MEMORANDUM

To: Zoning Board
From: Lauren A. Wasilauski, Open Space & Stewardship Director
Date: May 8, 2023
Re: BA-07-22 The Malvern School Properties, LP
Use Variance & Preliminary Site Plan
Block 28010 Lots 57 & 58
982 Georgetown-Franklin Turnpike (Somerset County Route 518)

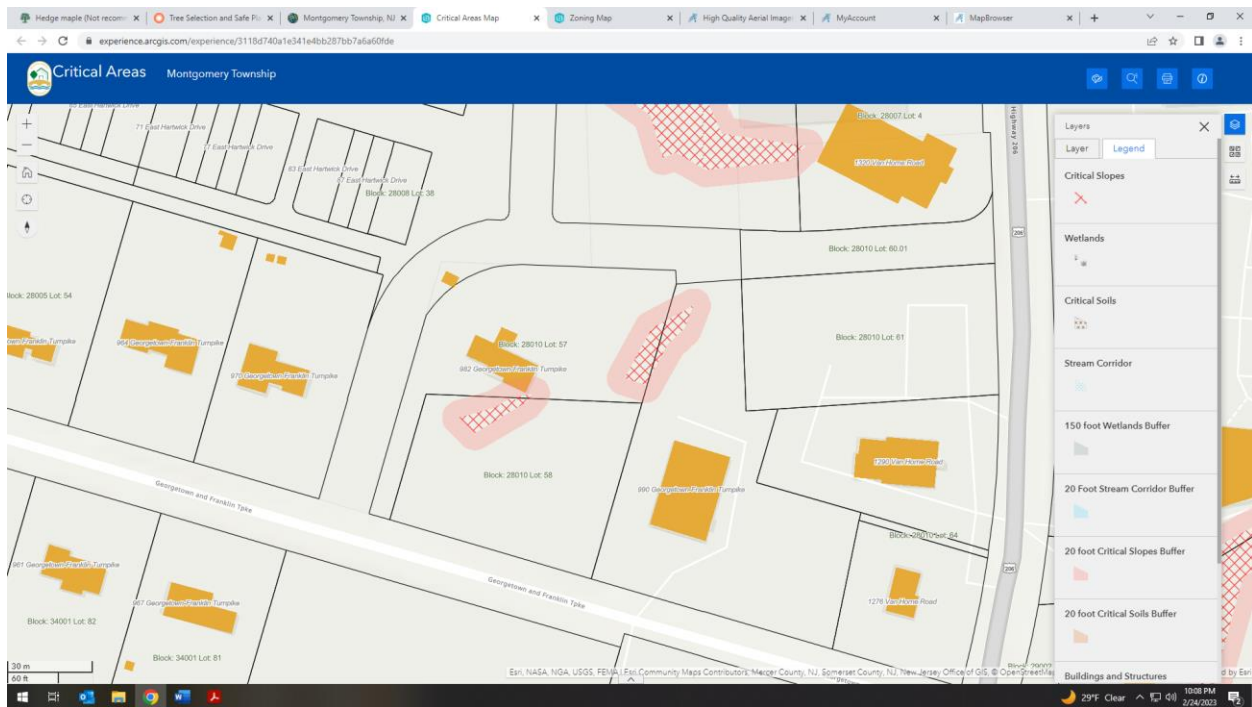
1. There are steep slopes on the property which the EIS report attributes to previous construction activities for the existing single-family dwelling (map below). Township Code Section 16-5.6e requires conservation easements or conservation easement deed restrictions on all critical areas. Because these steep slopes are not naturally occurring, this office does not recommend a conservation easement or deed restriction on these areas.
